ACCESSION NBR: 9304260276 DOC. DATE: 93/04/20 NOTARIZED: NO DOCKET #  
 FACIL: 50-244 Robert Emmet Ginna Nuclear Plant, Unit 1, Rochester G 05000244  
 AUTH. NAME AUTHOR AFFILIATION  
 MECREDY, R.C. Rochester Gas & Electric Corp.  
 RECIP. NAME RECIPIENT AFFILIATION  
 JOHNSON, A.R. Project Directorate I-3

SUBJECT: Responds to R Skokowski request for info re util 920915  
 application for amend to License DPR-18 per GL 90-06.  
 Actuation circuitry for PORV operation using nitrogen sys  
 tested from control room. Test cover sheet encl.

Subject: License Amendment Application Relative to  
Generic Letter 90-06  
R.E. Ginna Nuclear Power Plant  
Docket No. 50-244

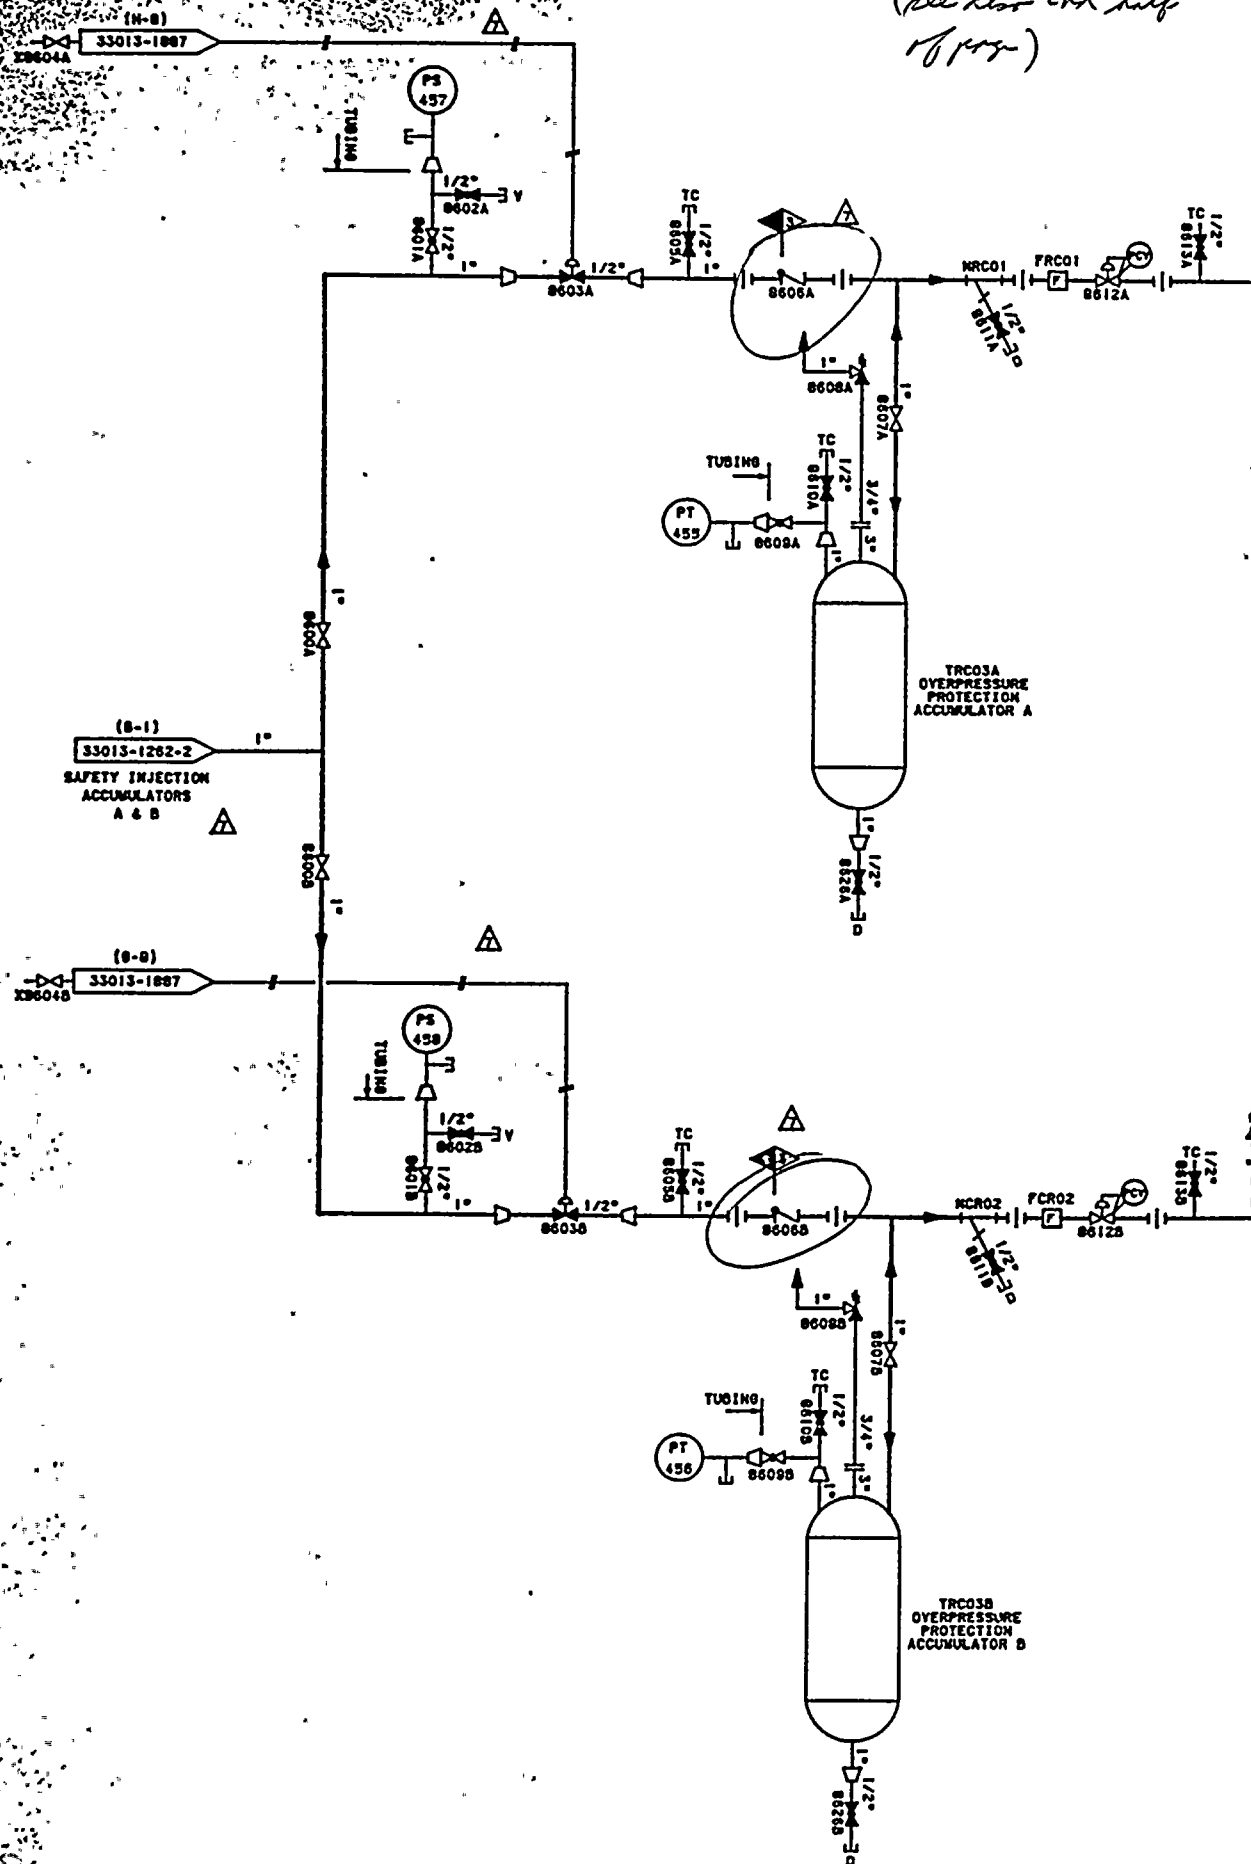
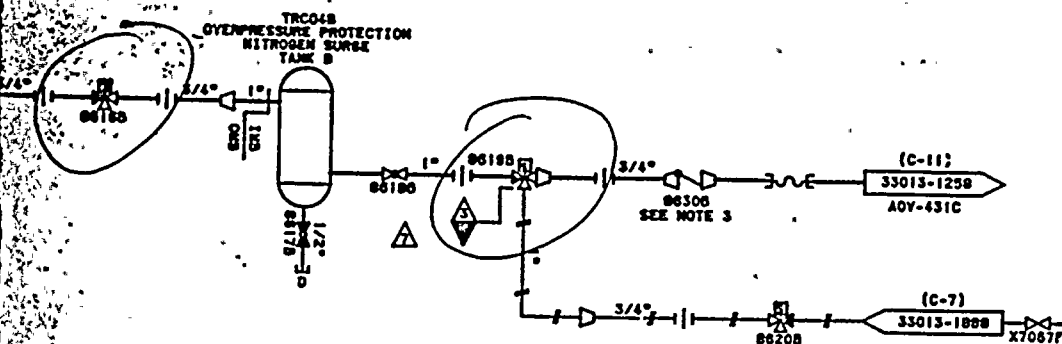
2. Question: Have the valves relied upon for operation of the PORVs by use of the Nitrogen system been placed into the IST Program?

The solenoid valves used for operation of the PORVs from the nitrogen system, as well as the check valve separating the nitrogen and air systems, are in RG&E's Inservice Testing Program. These are shown in the attached P&ID and selected pages from our IST Program (Attachment Q2)
